Subject: Response to WDNR Correspondence dated July 26, 2022  
Martinizing Dry Cleaning Site  
1730 State St.  
Racine, Wisconsin 53404  
BRRTS No. 02-52-549890 / FID No. 252251010  
Project No. 1E-0909013

***Change Order No. 3***  
***(October 27, 2015; REV: July 8, 2020)***

Subject: Change Order No. 3 - Proposed Additional Site Investigation  
and Cost Estimate  
Martinizing Dry Cleaning Site  
1730 State Street  
Racine, Wisconsin  
Proposal No. 1EP-1904012  
BRRTS No. 02-52-549890/FID No. 252251010

**FIGURE 1**  
 SITE PLAN  
 MARTINIZING  
 1730 STATE STREET  
 RACINE, WISCONSIN

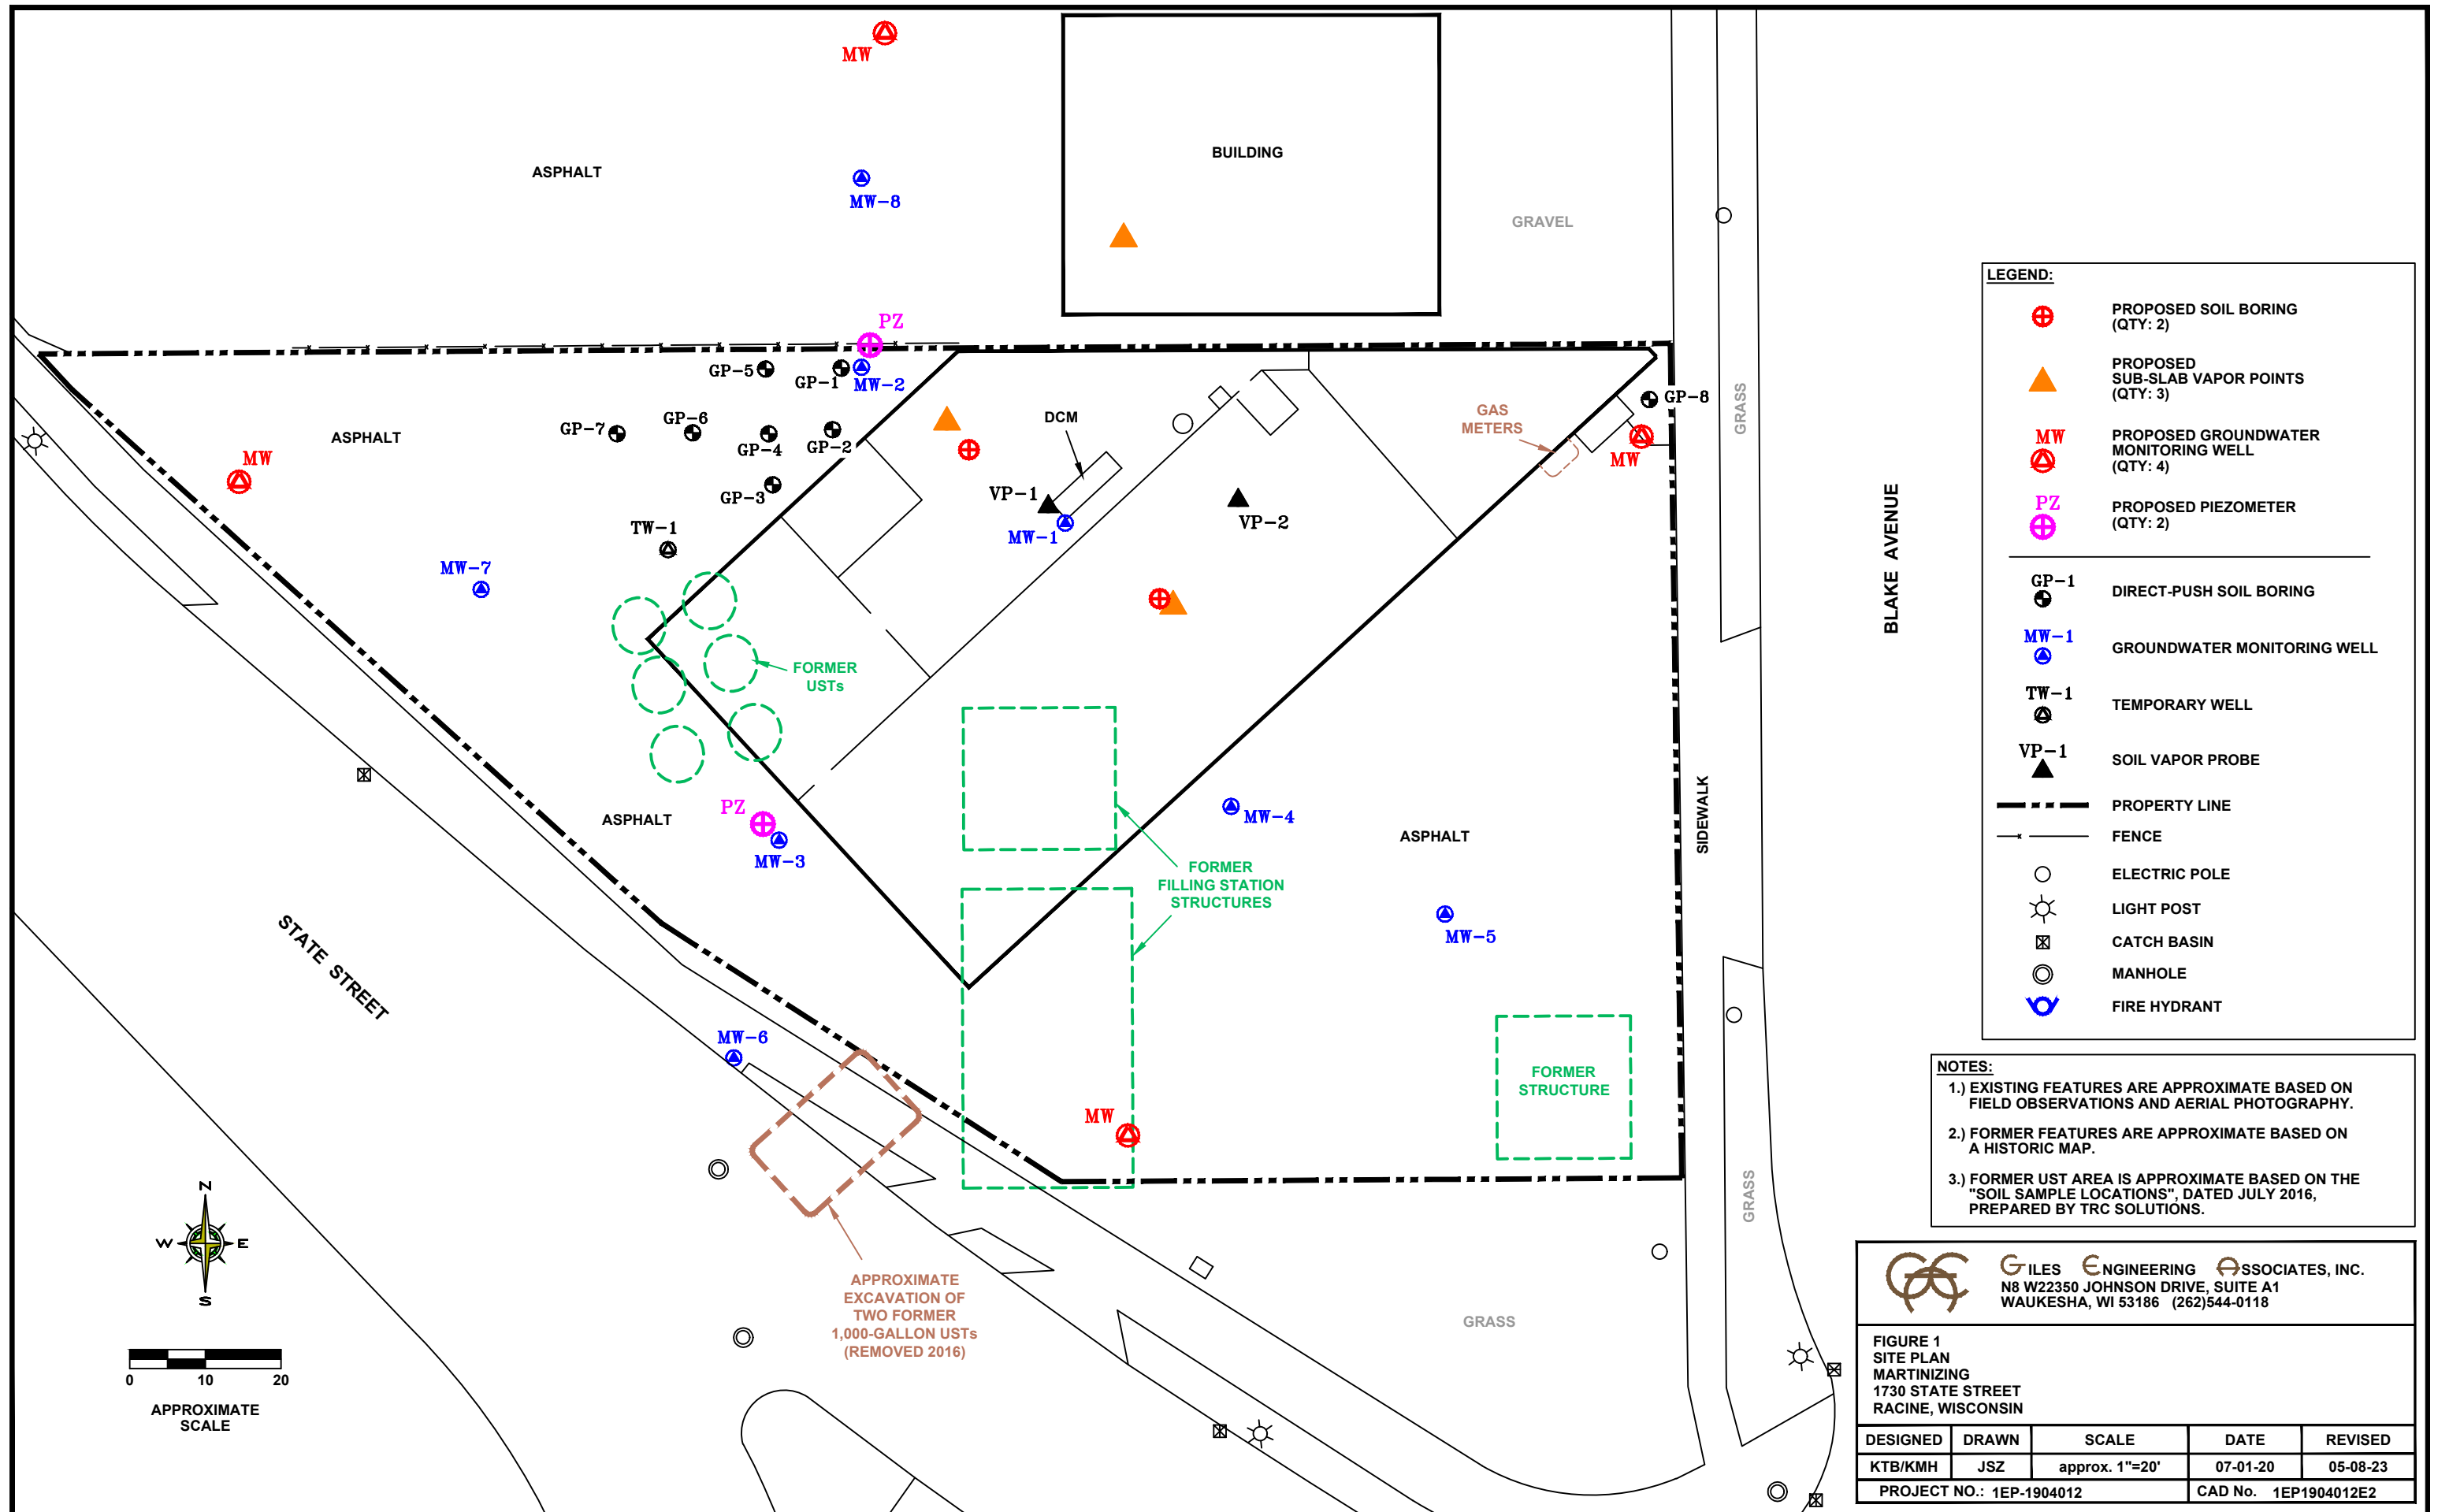
***2. Evaluate whether the proposed piezometer located near MW-5 would be placed closer to the western side of the property near MW-3. The DNR concurs with locating a piezometer near MW-2. Provide the proposed depths for the piezometers compared to the depths of existing monitoring wells.***

After considering your thought, Giles will relocate the piezometer from near MW-5 to MW-3. The existing wells were installed to depths of either 13 or 16 feet. The piezometer depths will be determined in the field based on soil types encountered and will likely be greater than twenty-five (25) feet or more with a 5-foot screen. See the revised Figure 1 within the Revised proposal dated July 8, 2020, which is attached.
